1957 - 1958 Corvette: Service News: Corvette 4-Speed Transmission - Harsh Shift Into Third Speed

Source: Chevrolet Service News

Date: December, 1957

Subject: Corvette 4-Speed Transmission - Harsh Shift Into Third Speed

Fig. 3--Checking Third Speed Gear

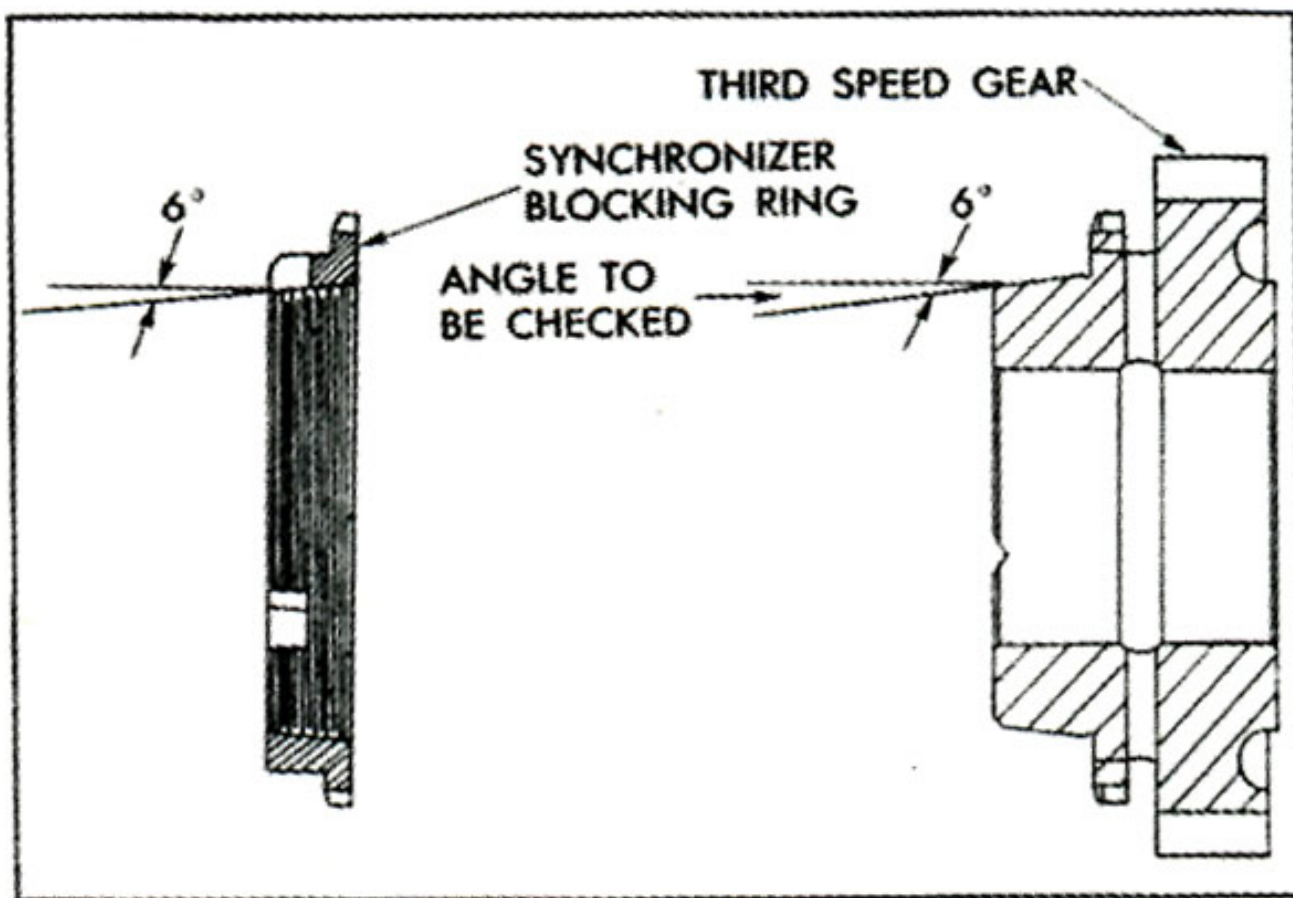
Some 1957 and 1958 Corvette four-speed transmissions have been built incorporating a third speed gear with 7° cone angle rather than the specified 6° , as illustrated in Figure 3. This may cause a harsh shift into third speed due to the resultant improper engagement of the synchronizer blocking ring and third speed gear cone.

The suggested correction, if the harsh shift is encountered, is to replace the third speed gear assembly No. 3743452 and the synchronizer blocking ring No. 3709348.

1. Coat I.D. of blocking ring lightly with a dye such as Prussian Blue.
2. Carefully install the blocking ring on the third gear cone to obtain an engagement impression.
3. If the Prussian Blue impression on the cone is all at the rear (or predominantly at the rear) the cone angle can be assumed to be 7° and should not be used. If the Prussian Blue is more or less evenly distributed on the cone surface, the angle is correct.
